**PLANNED UNIT DEVELOPMENT
AMENDED PRELIMINARY DEVELOPMENT PLAN
MCKITRICK PROPERTY/I-270 AND COFFMAN ROAD**

June 15, 1995
Revised: March 25, 1997
(Revisions in bold italics)

Planned Unit Development
Subarea 4, Single-Family
Killilea
PRELIMINARY DEVELOPMENT PLAN

HOUSE #1

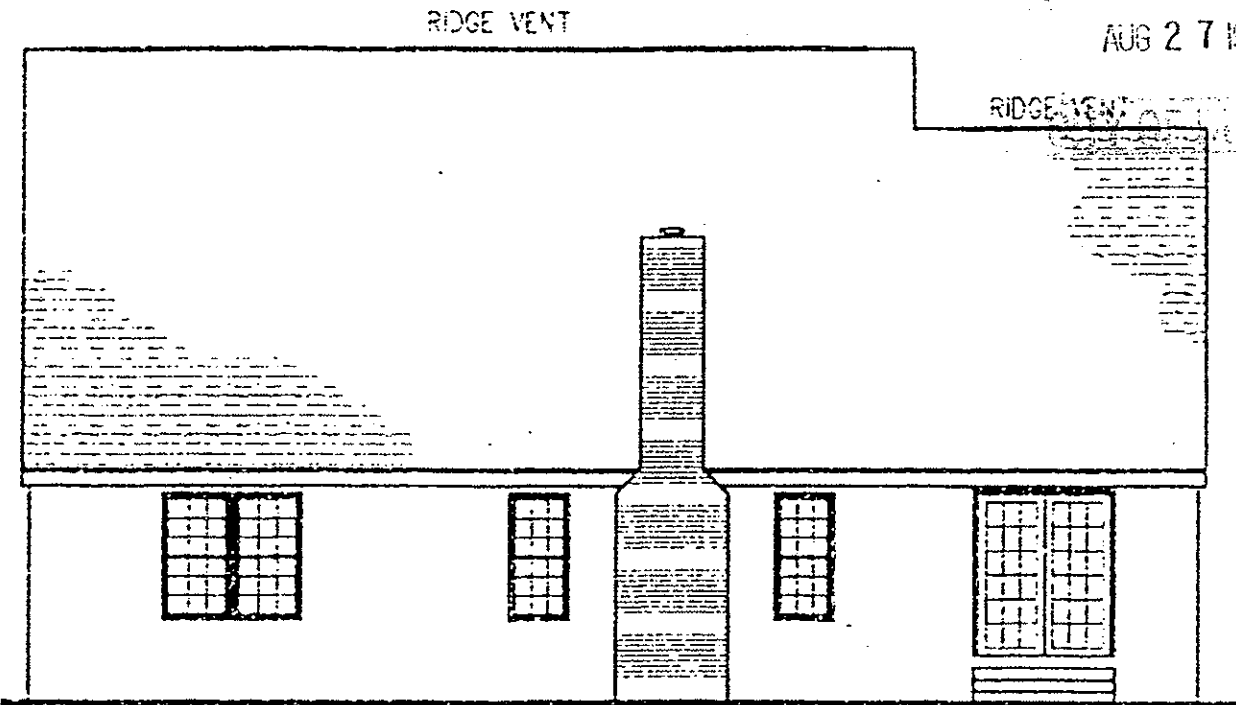
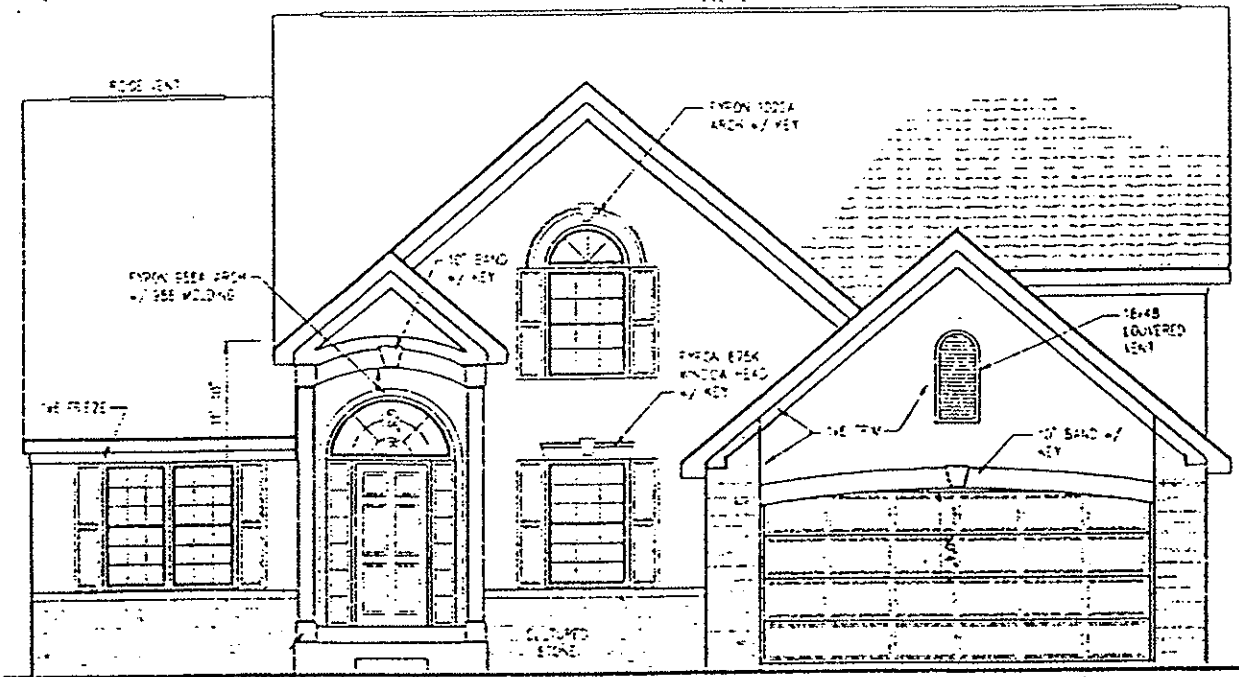
HOUSE #1 As submitted, this example not acceptable

The following is recommended:

- Masonry exterior chimney, i.e., brick, stone, or stucco stone (same material as front elevation)
- Trim relief around windows and doors to match front elevation

HOUSE #1

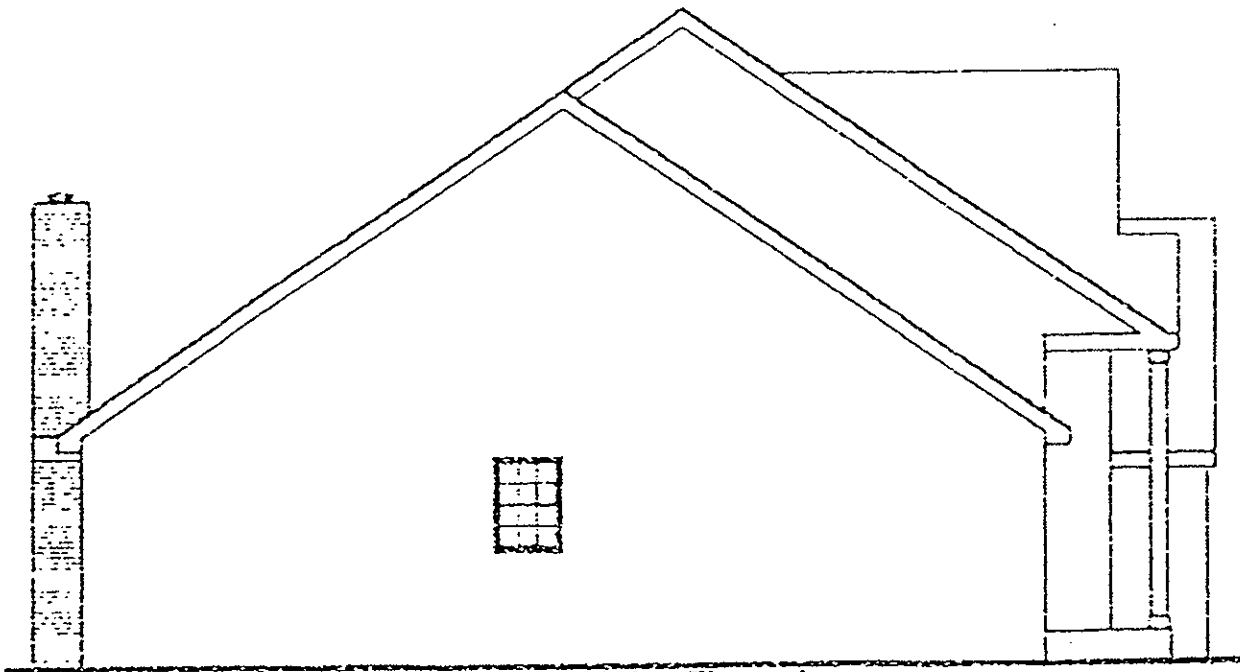
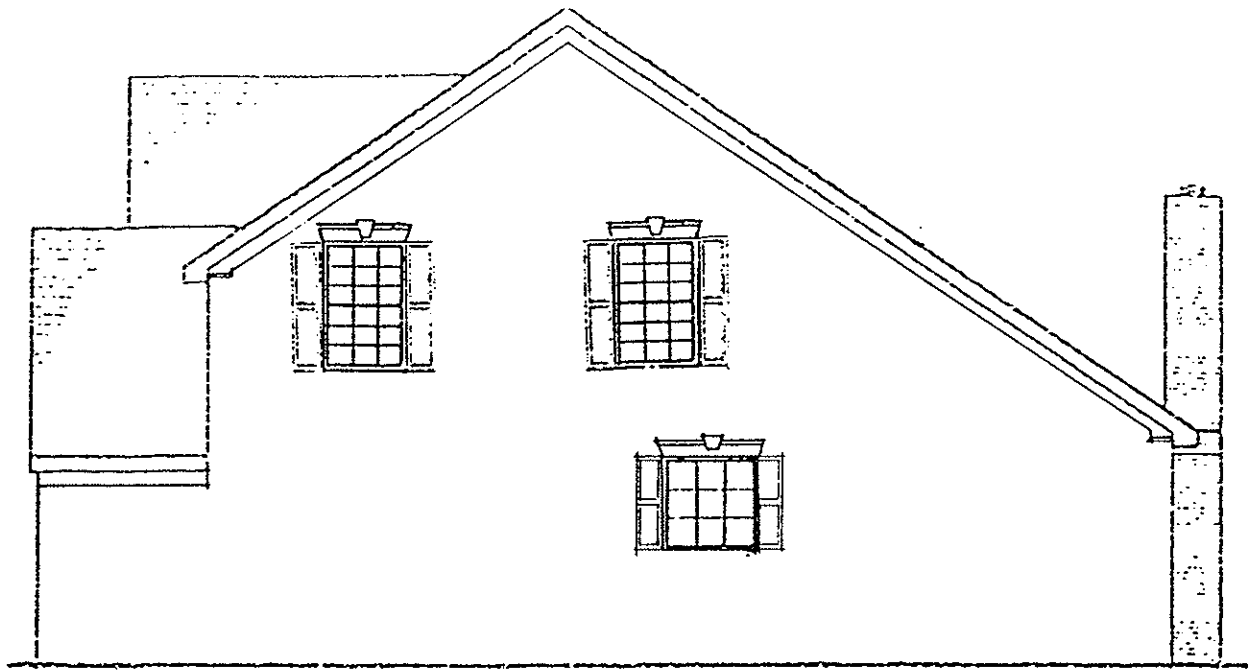
HOUSE #1 As submitted, this example not acceptable

The following is recommended:

- Masonry exterior chimney, i.e., brick, stone, or stucco stone (same material as front elevation)
- Trim relief around windows and doors to match front elevation

HOUSE #2

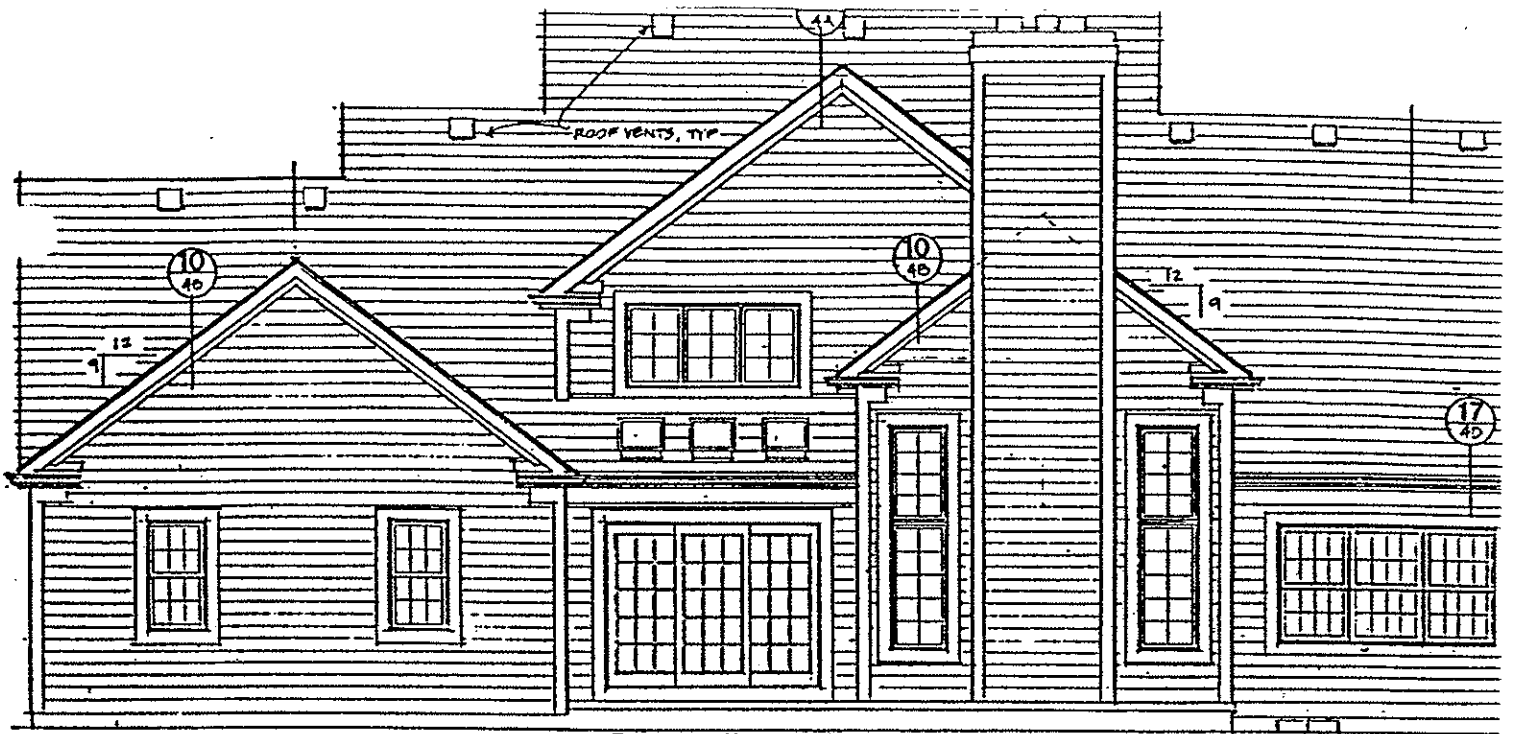
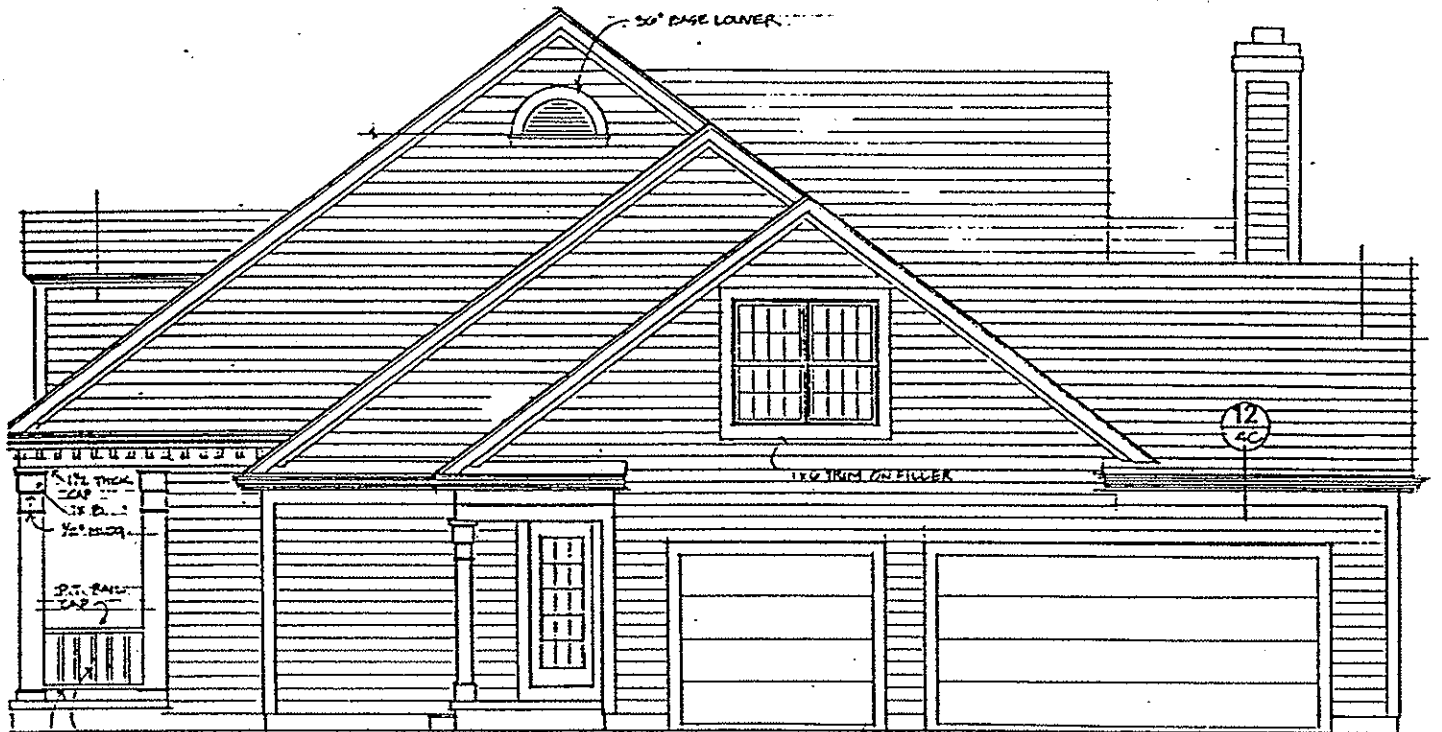
As submitted, this example not acceptable

The following is recommended:

- Masonry exterior chimney, i.e., brick, stone, or stucco stone (same material as front elevation)
- Paneled garage doors

HOUSE #2

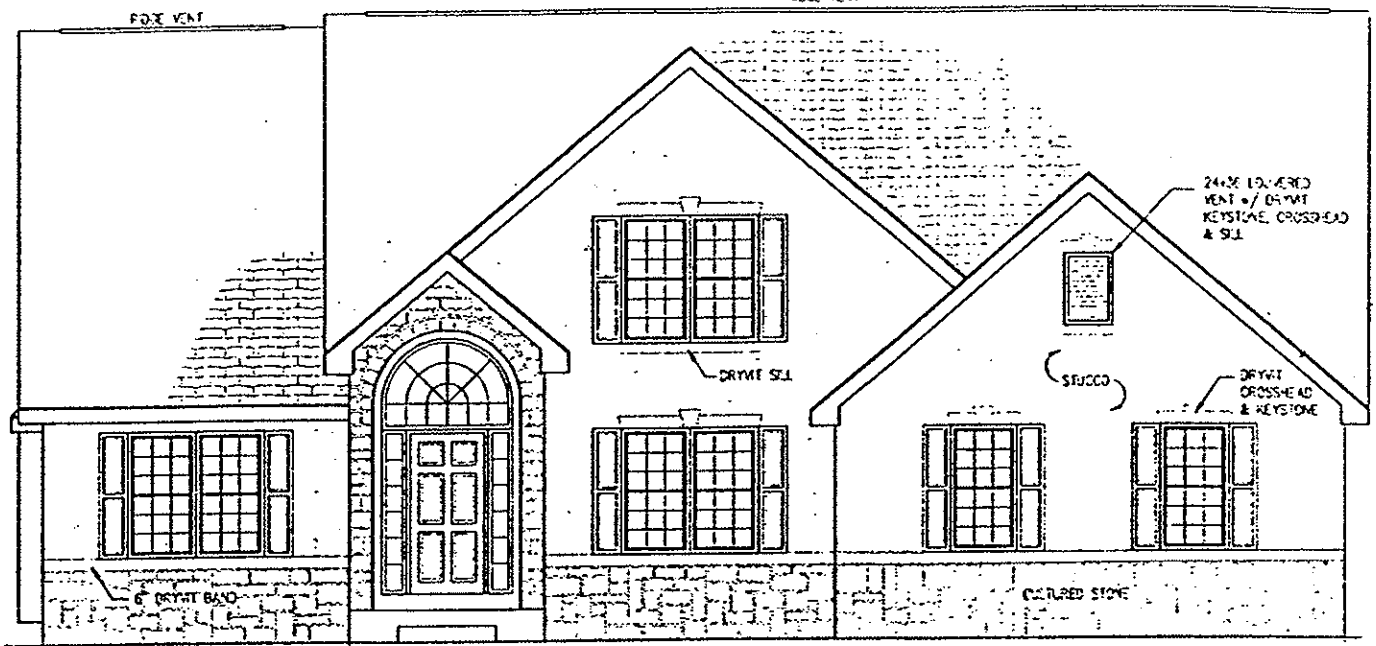
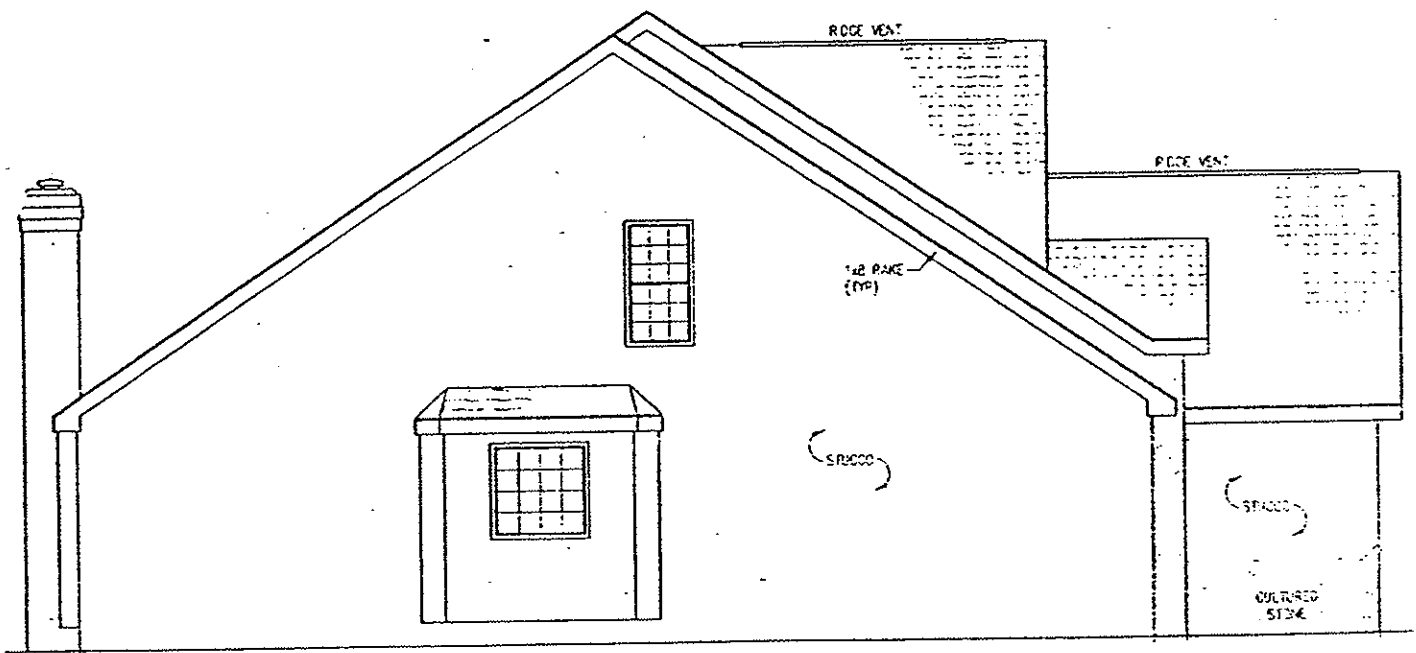
As submitted, this example not acceptable

The following is recommended:

- Masonry exterior chimney, i.e., brick, stone, or stucco stone (same material as front elevation)
- Trim relief or details around windows and doors to match front elevation

HOUSE #3

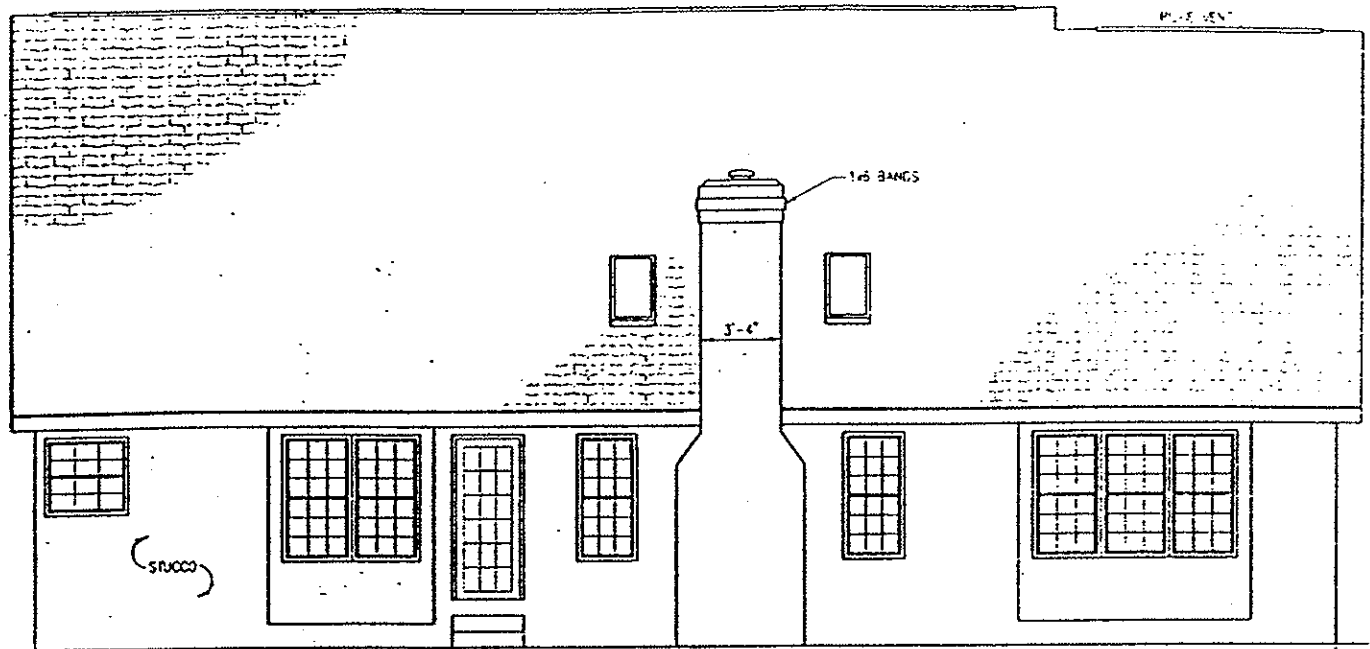
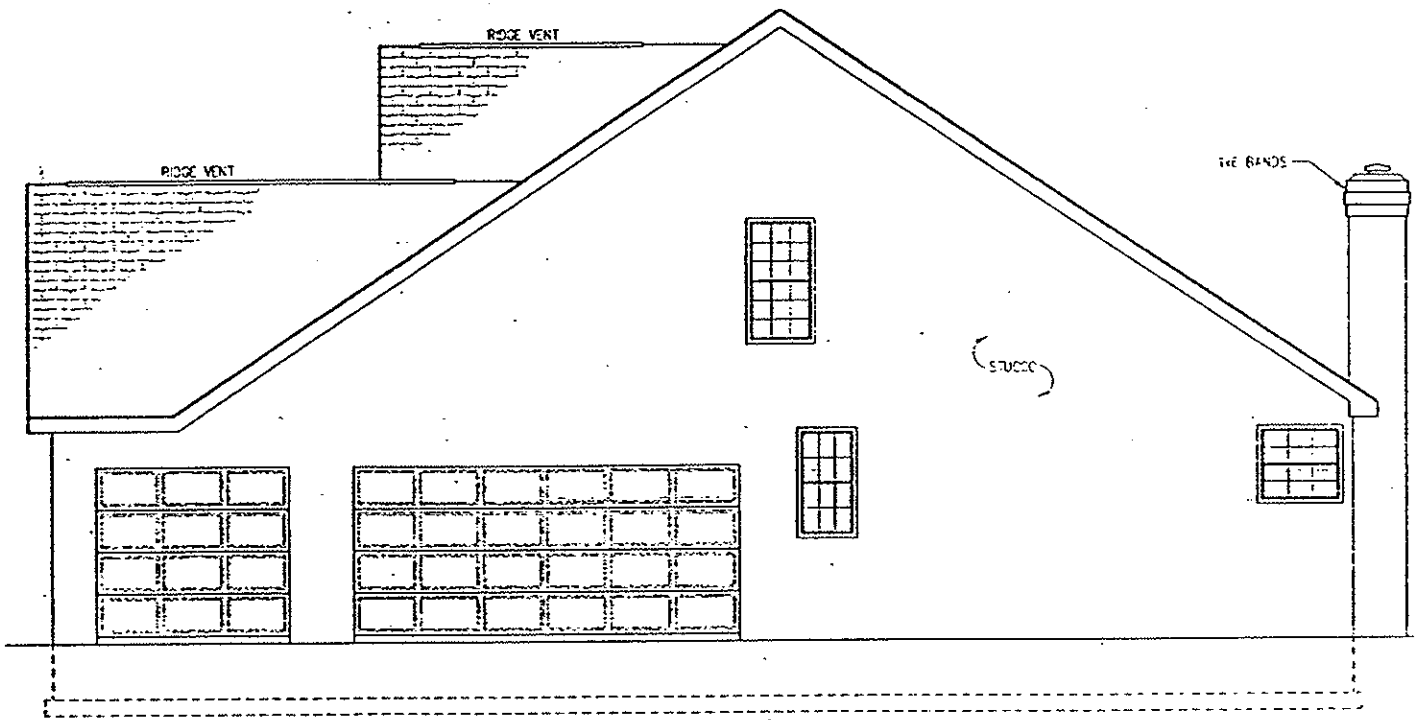
As submitted, this example not acceptable

The following is recommended:

- Masonry exterior chimney, i.e., brick, stone, or stucco stone (same material as front elevation)
- Trim relief or details around windows and doors to match front elevation

HOUSE #4 As submitted, this example not acceptable

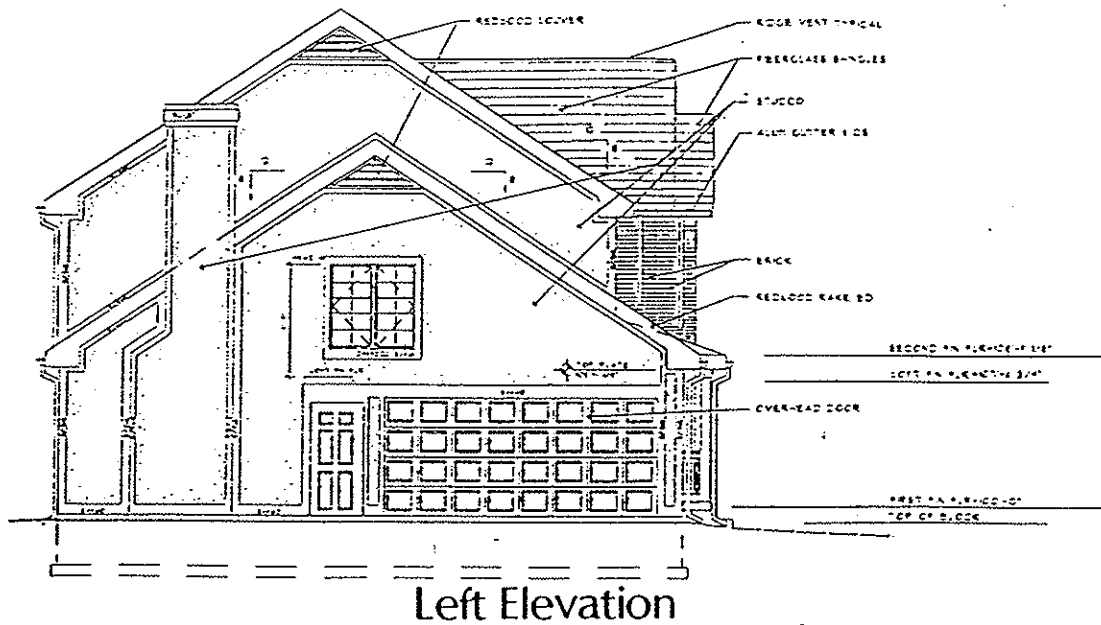
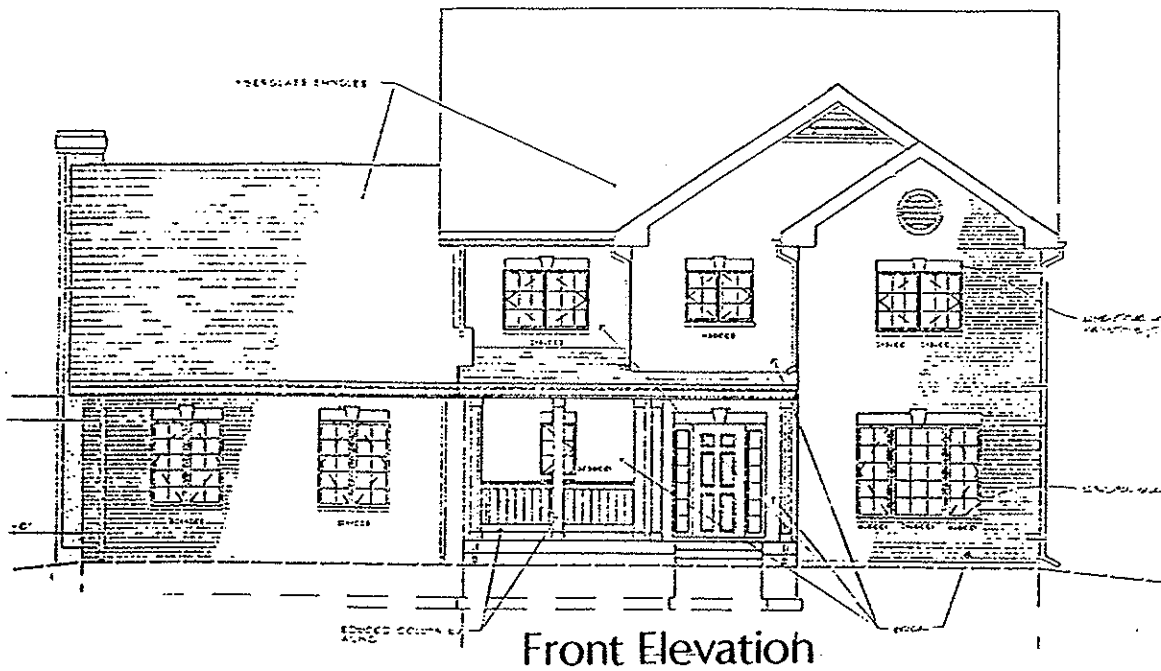
The following is recommended:

- Masonry exterior chimney, i.e., brick, stone, or stucco stone (same material as front elevation)
